Project: R.077223.220

Rehabilitation of the Lachine Canal walls, Reach 4 – Sectors 14 to 17 Lachine Canal national historic site

Object: ADDENDA # 1

August 15th, 2018

AD-01

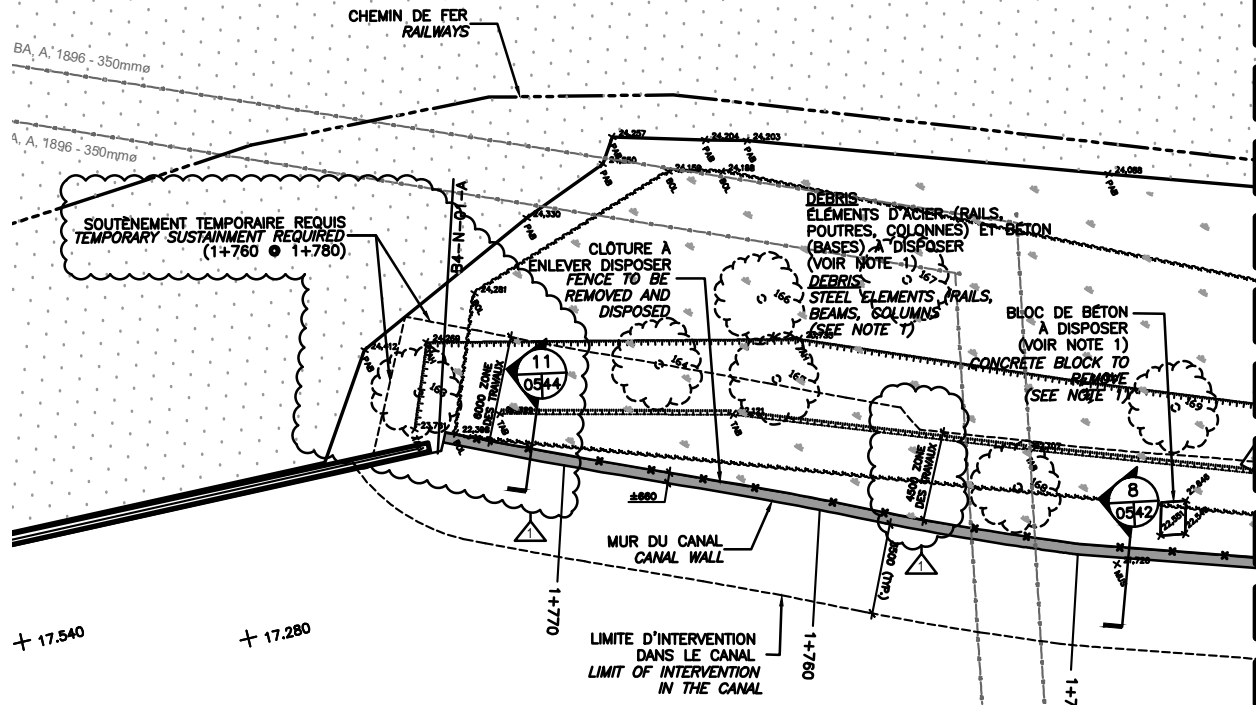
- .1 Easement limit has been added in the legend, see AD-01 in the appendix of this document.

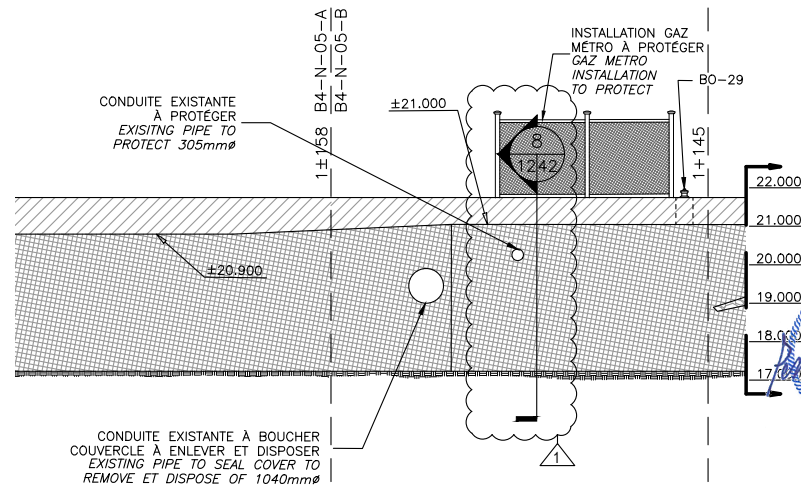
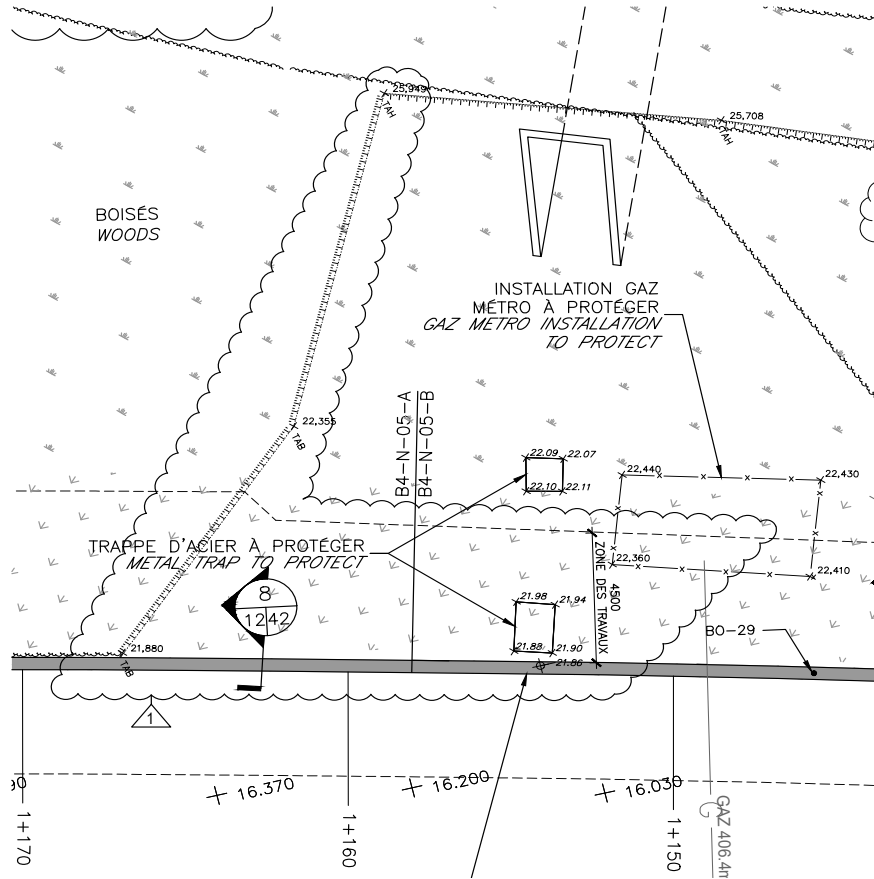
- .1 Additional information has been added regarding the temporary support, see AD-02 in the appendix of this document.
- .2 An additional general note has been added:
« *Intervention zone: This zone includes the clearing/grubbing to position the temporary support, to allow the creation of a circulation path for the wall access and an excavation, backfilling zone.* »

AD-04

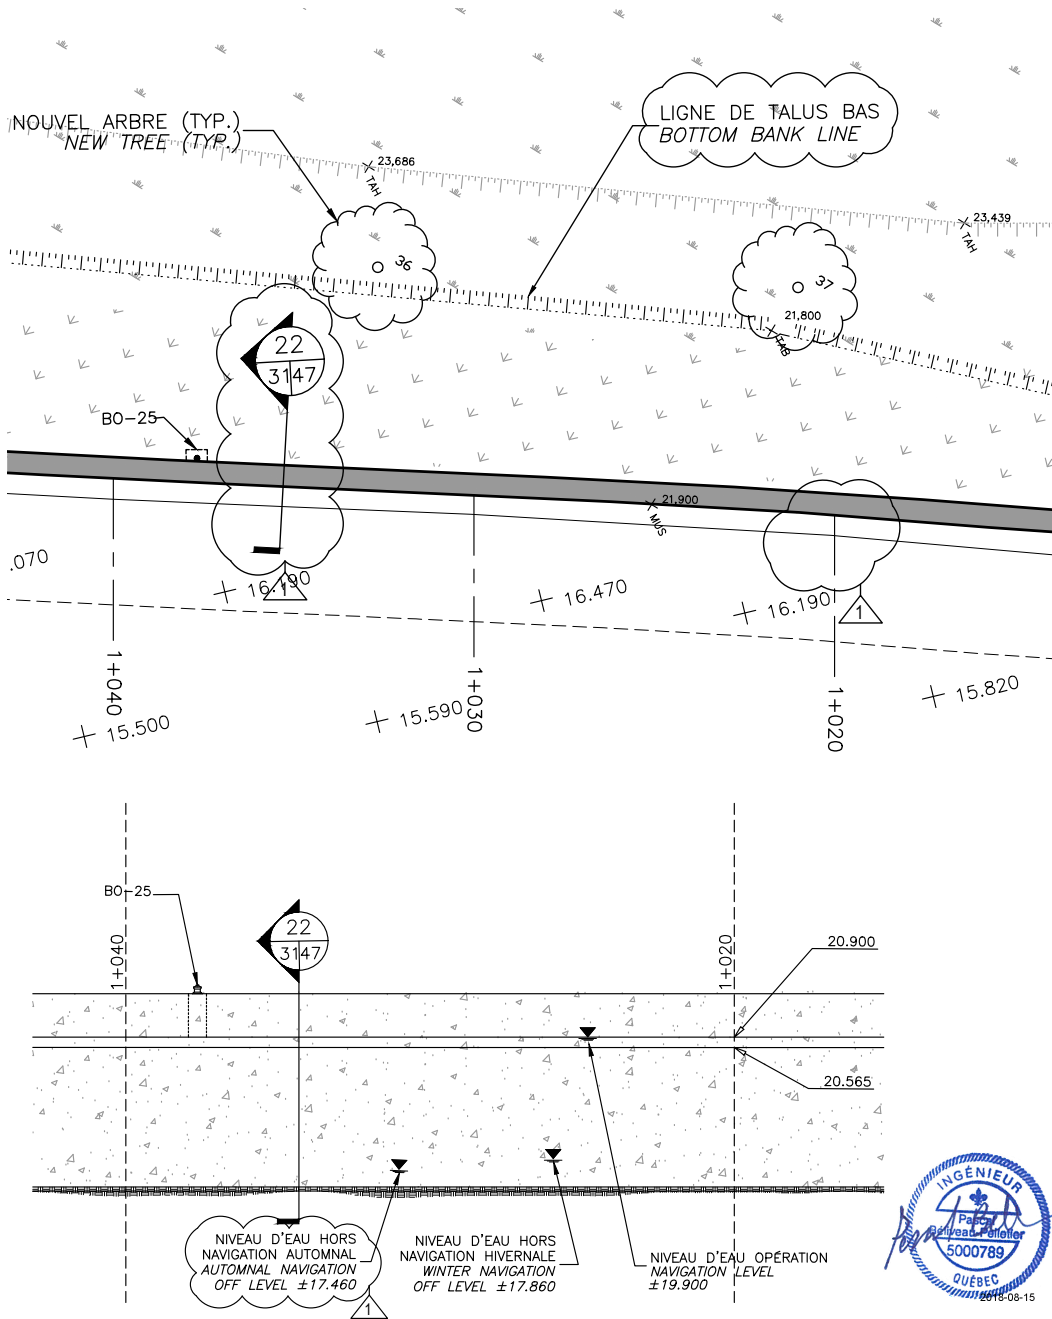
.1 New crowning wall symbol has been added to the legend, see AD-04 in the appendix of this document.

AD-05

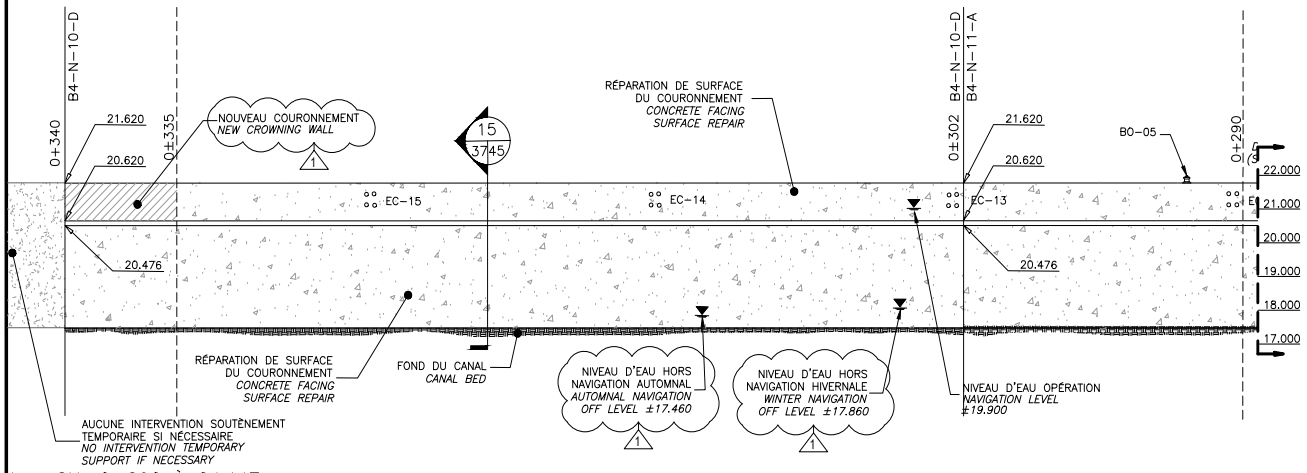
.1 Chain 1+020, the difference of the tablets thickness has been removed, see AD-05 in the appendix of this document.

.2 Section located on chain 1+035 has been changed section 22/S47, see AD-05 in the appendix of this document.

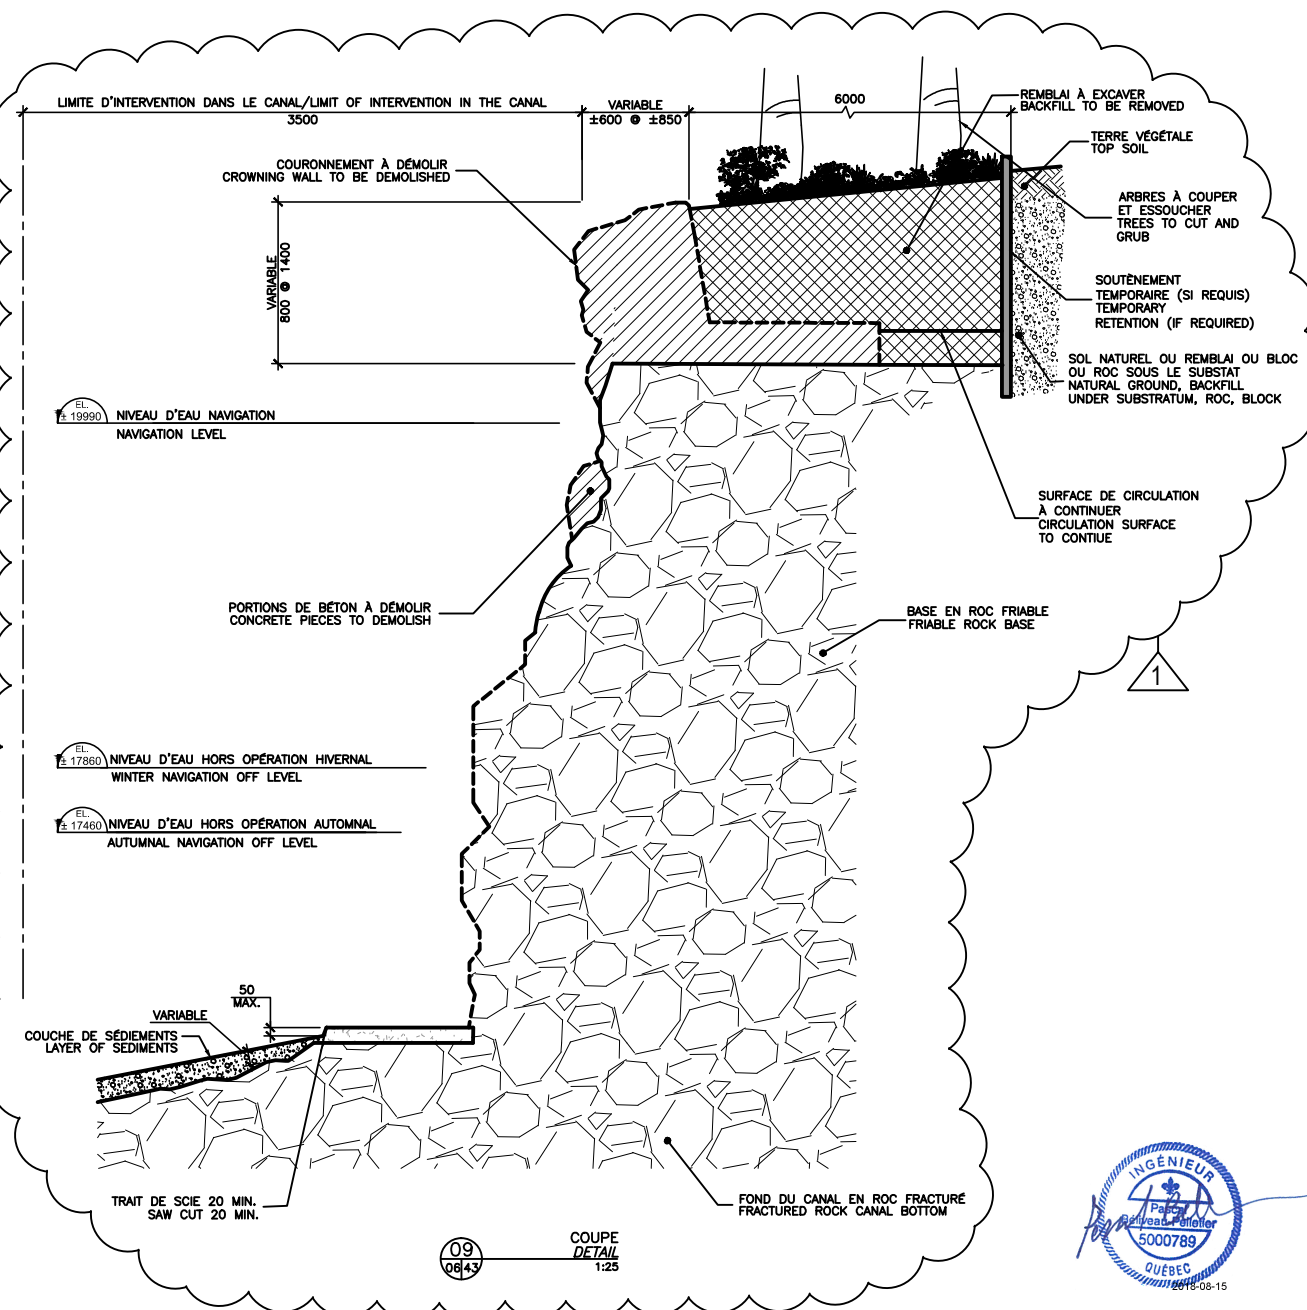
.1 Between chains 0+335 @ 0+340, new crowning wall has been added, see AD-06 in the appendix of this document.

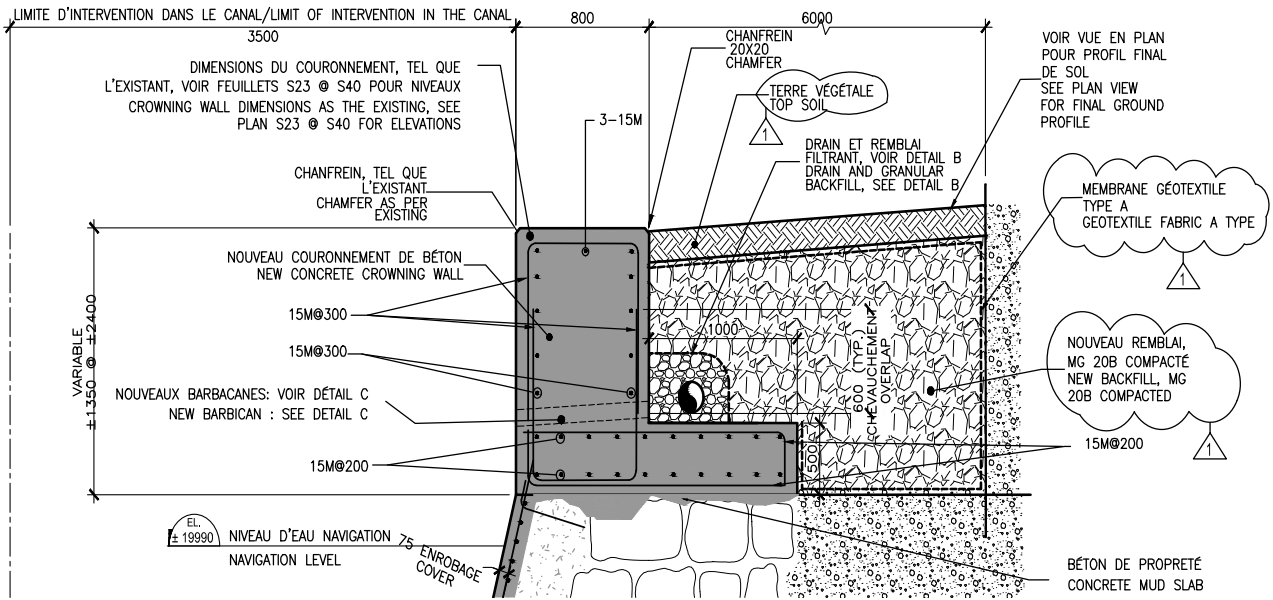
- .1 Modification of section 9, see D-07 in the appendix of this document.

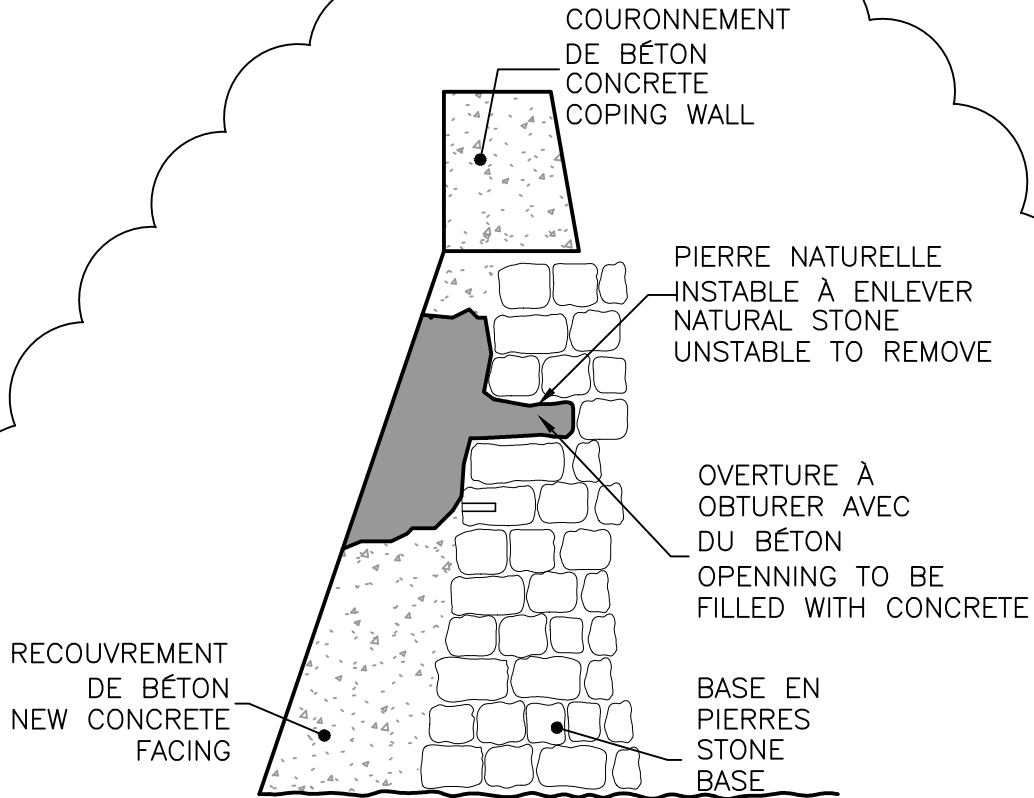
- .1 Modification of section 12, see AD-09 in the appendix of this document.
- .2 In sections 13, 14, 15, the reference of the reinforcement detail has been changed to U/S51.

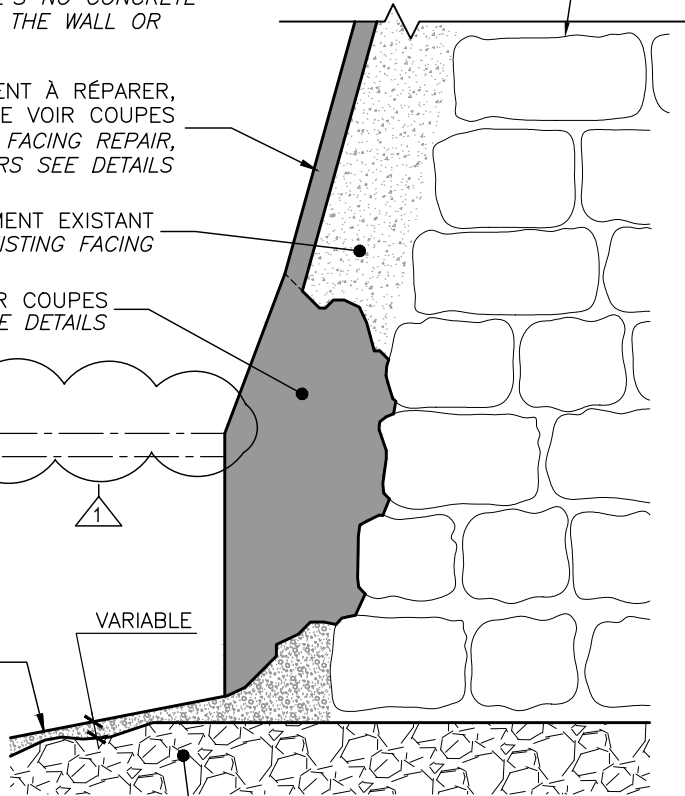
- .1 Modification of the detail H, see AD-10 in the appendix of this document.
